# Product Change Notice (PCN)

PCN Number: **PCN-0450073R-01**

Product(s) Affected: *MJ-3536*

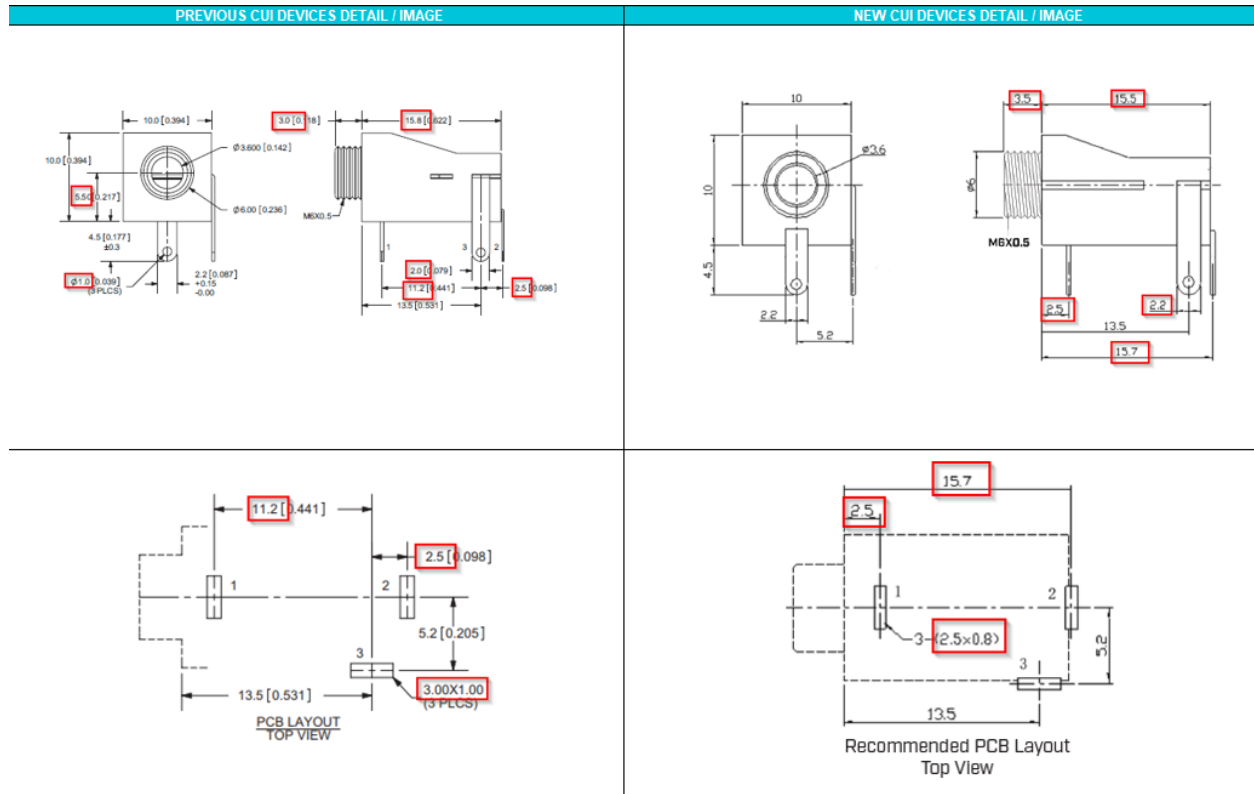
Description of Change: *Minor Housing and footprint differences. Material Change on the housing and terminals. See image Below*

PREVIOUS CUI DEVICES DETAIL / IMAGE			NEW CUI DEVICES DETAIL / IMAGE		
	MATERIAL	PLATING	DESCRIPTION	MATERIAL	PLATING/COLOR
terminal 1	brass	tin	terminal 1	brass	silver
terminal 2	copper alloy	tin	terminal 2	brass	silver
terminal 3	brass	tin	terminal 3	brass	silver
bushing	brass	nickel	bushing	brass	tin
plastic	PBT		housing	PA (UL94V-0)	black
